3.11 KONTROLL AV PRODUKSJONSTEGNINGER LAFT

Dato:	15.6.15	Prosjektnavn:	Kjetil Solberg
Tegning:	Produksjonstegninger		
Tegner:	HSK	Nivå:	Sjekk 1

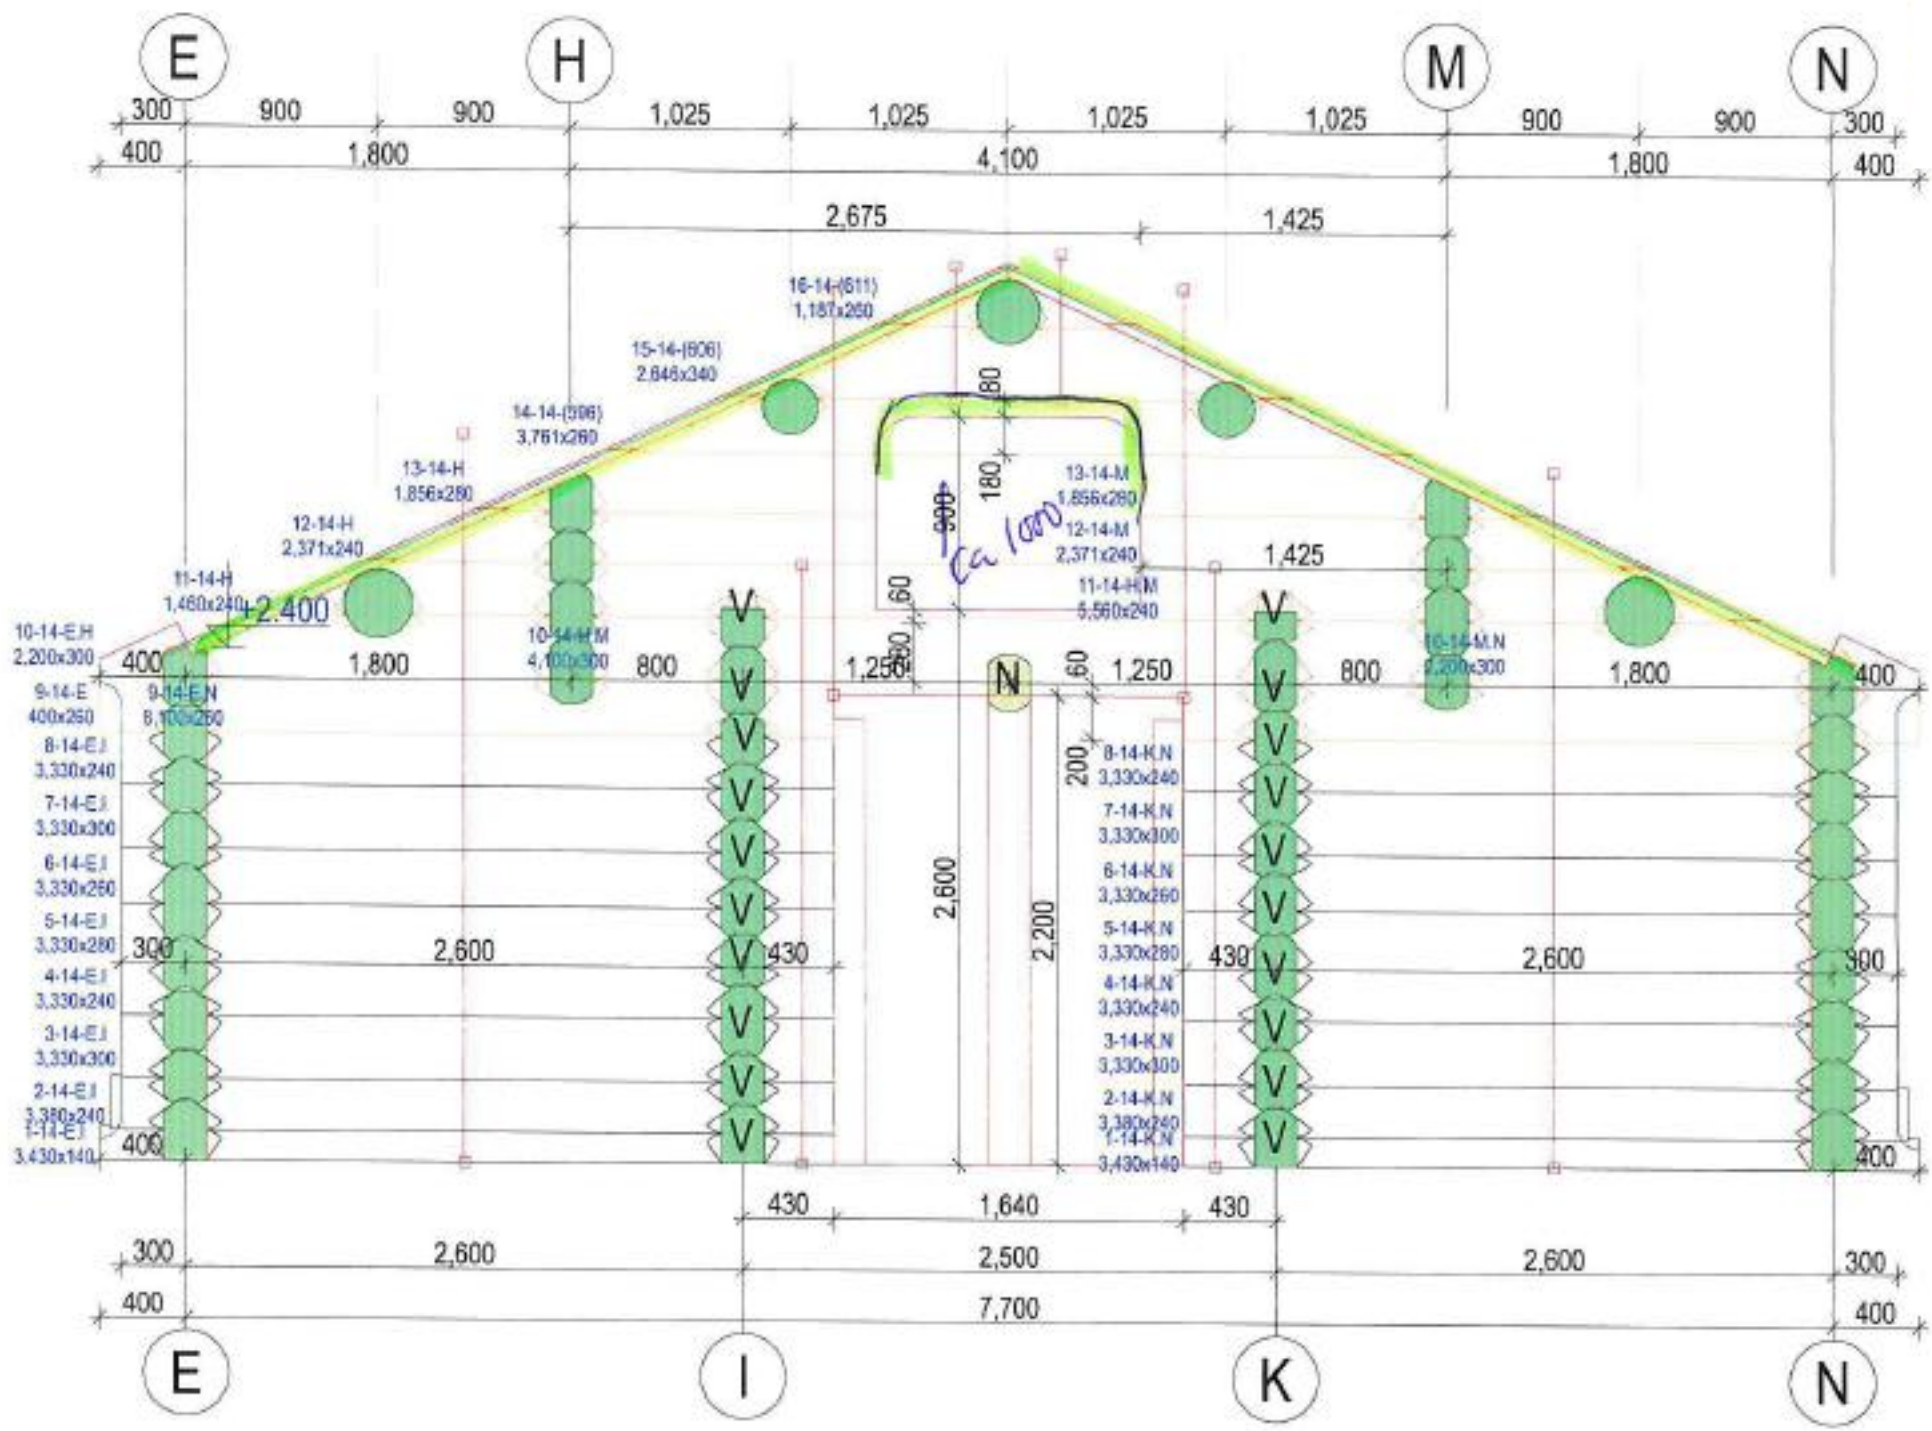
These walls are longer than 8000 mm, it is not allowed. Required for other solution

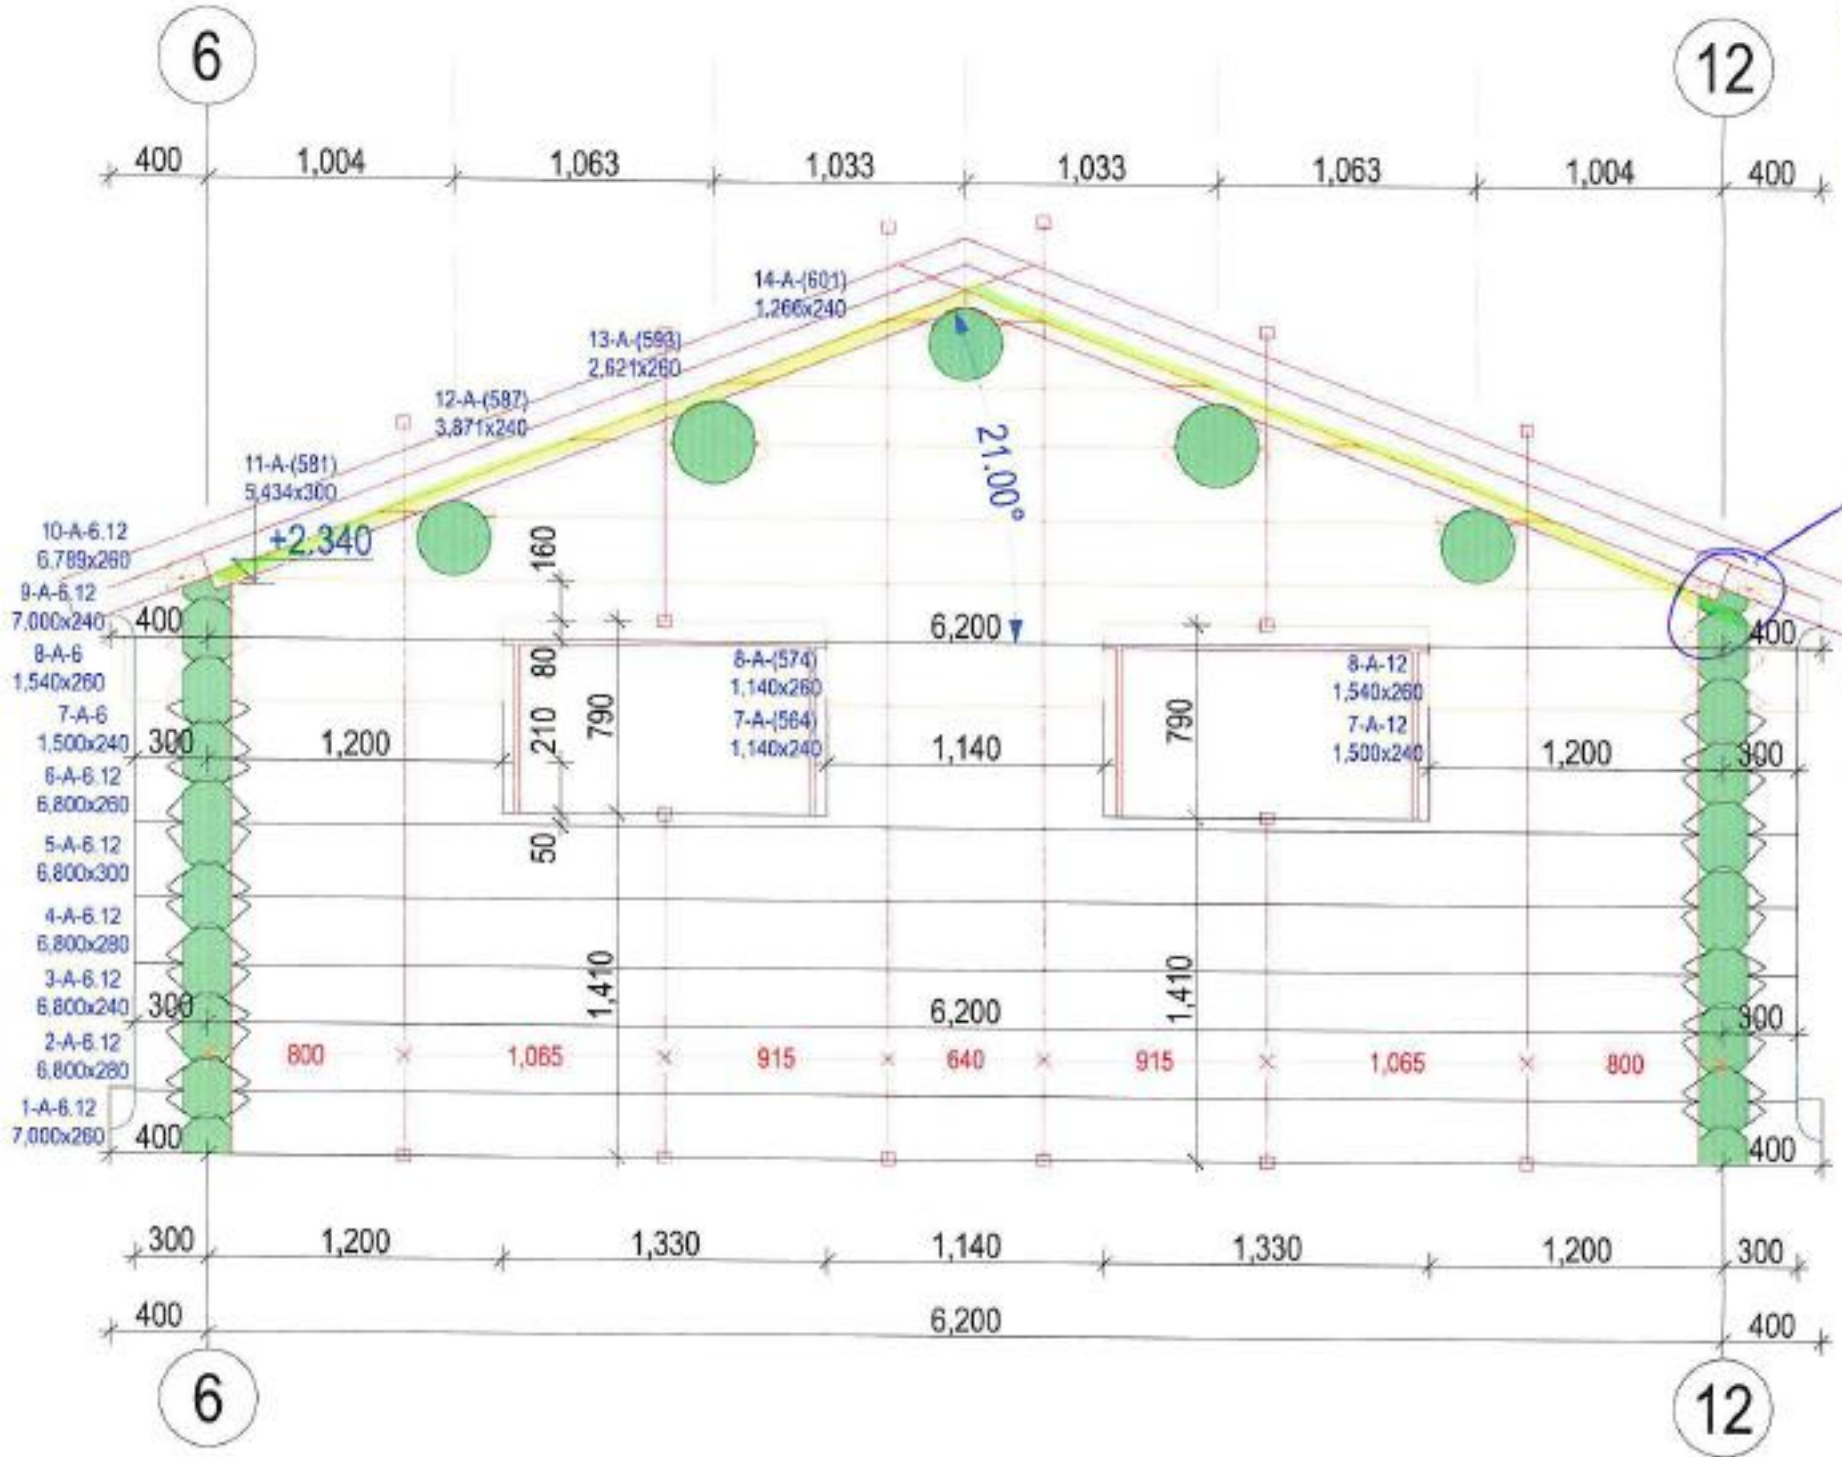
Very small top log
 Bigger!!

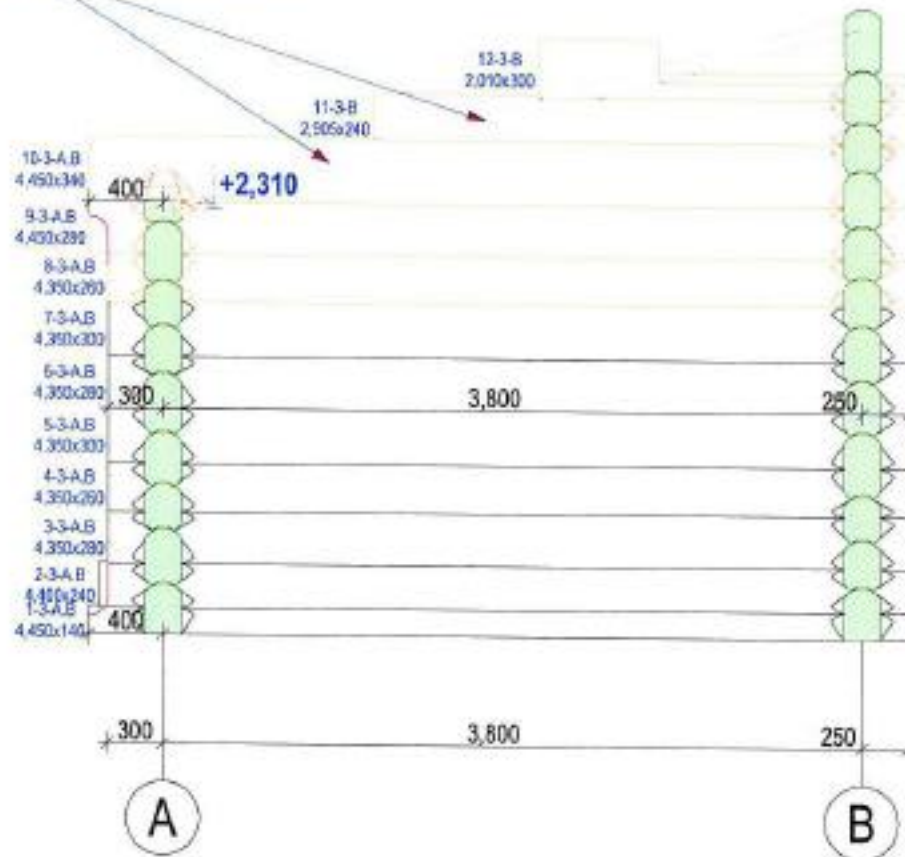
The groove for the roof - need to make?

opening window up to top. OK 4050?

All over flat log part in top

YES - 37mm

Just deliver as we can cut and finish in Norway. Make with

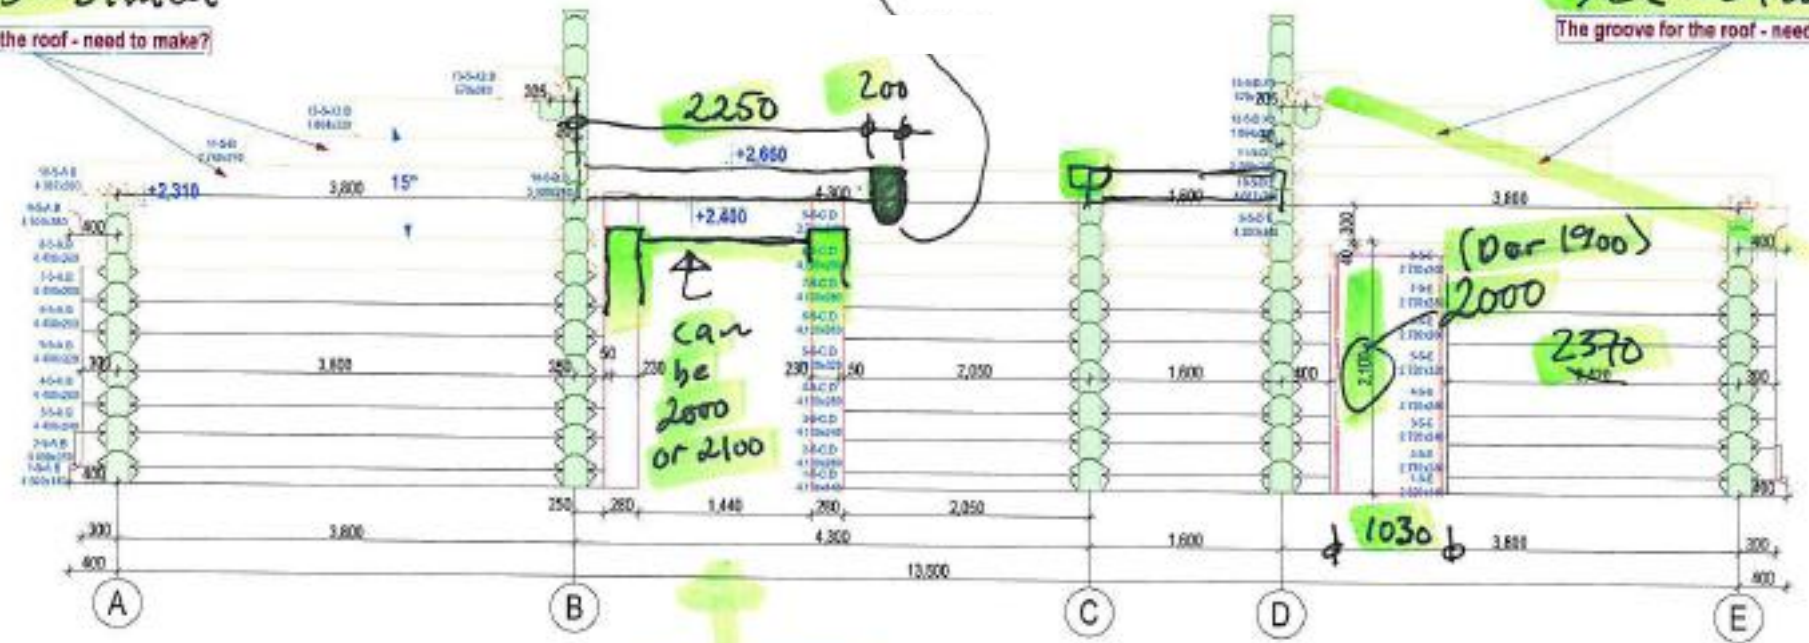
Floor beams.

opening for stairs.

The groove for the roof - need to make?

YES - 37mm

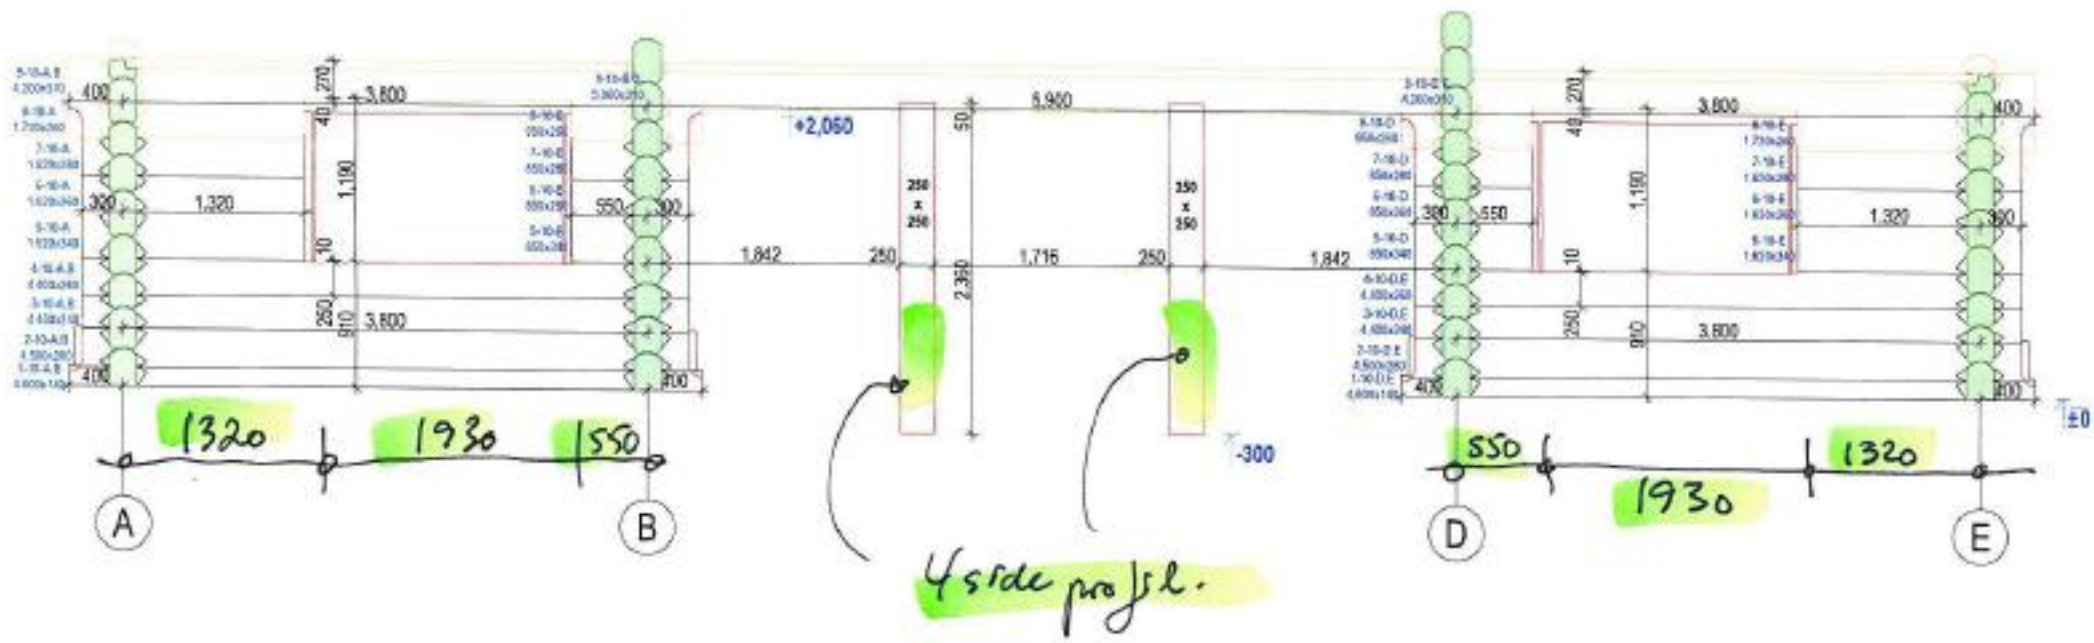
4050
 Apron
 also up to log.
 also 2000

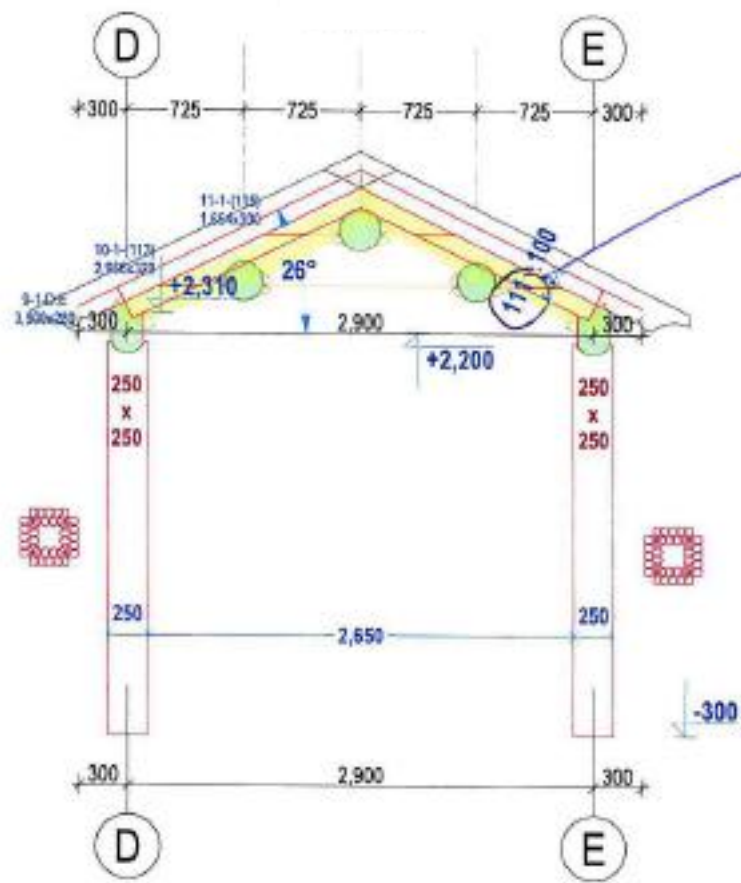
Column 150x150

Splices.

100x150 Column in corner

Make also drawings in drawings all

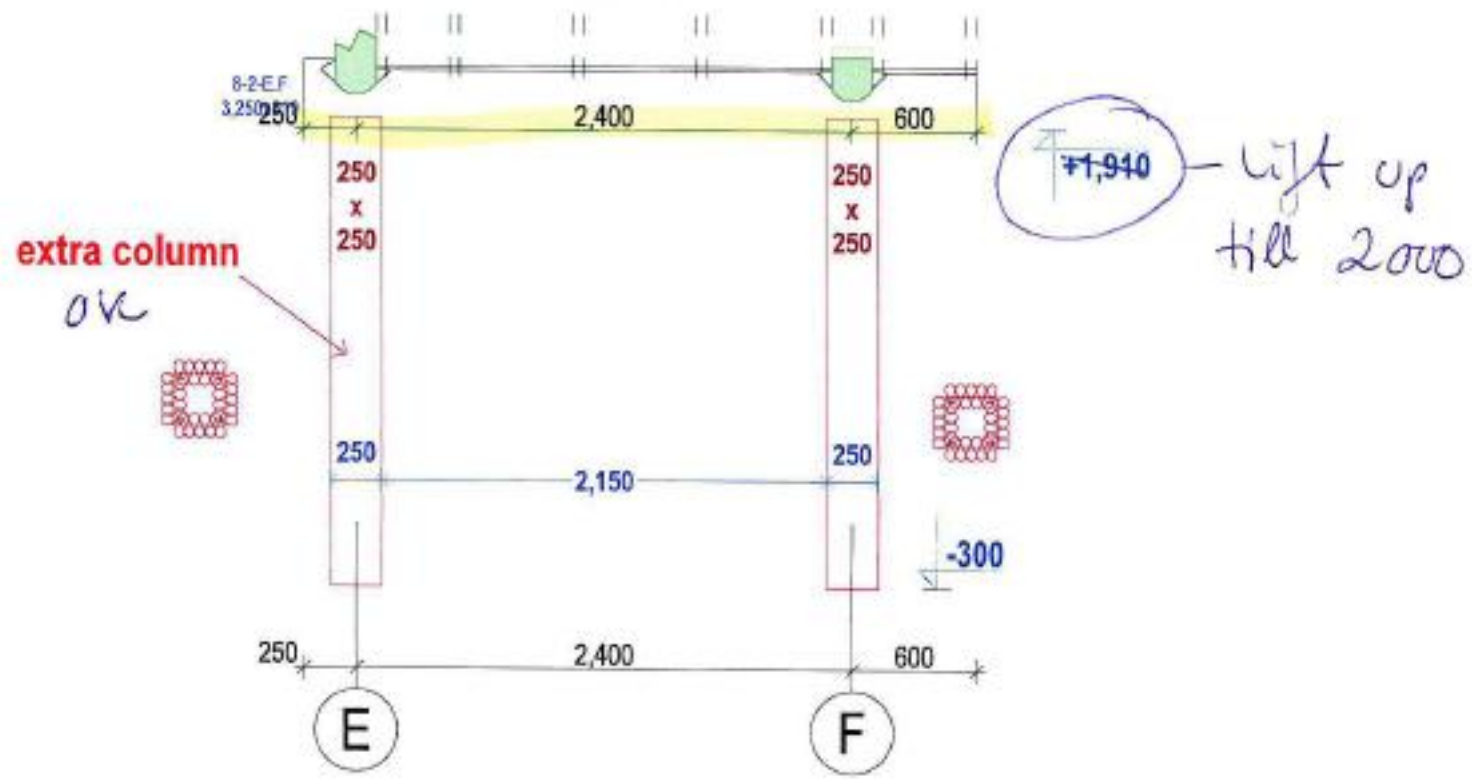
Standard 74mm.

Always this business. if its a bigger cabin > 150m² like this we use extra 50mm let over spars.

This we change with Ervins last year.!

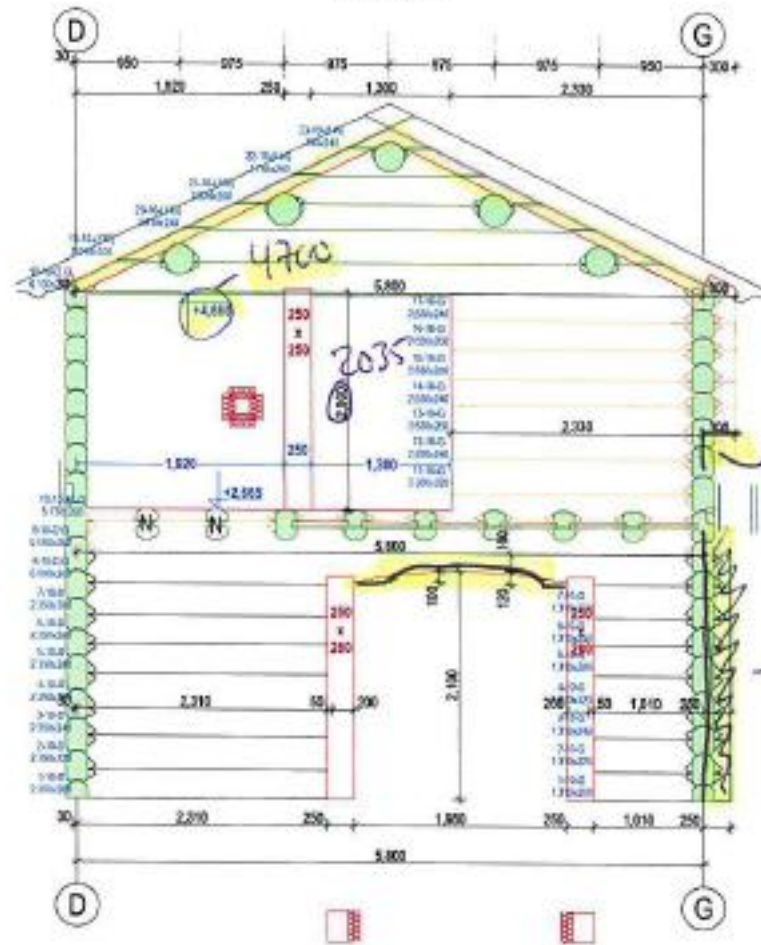
Log stop in center wall G
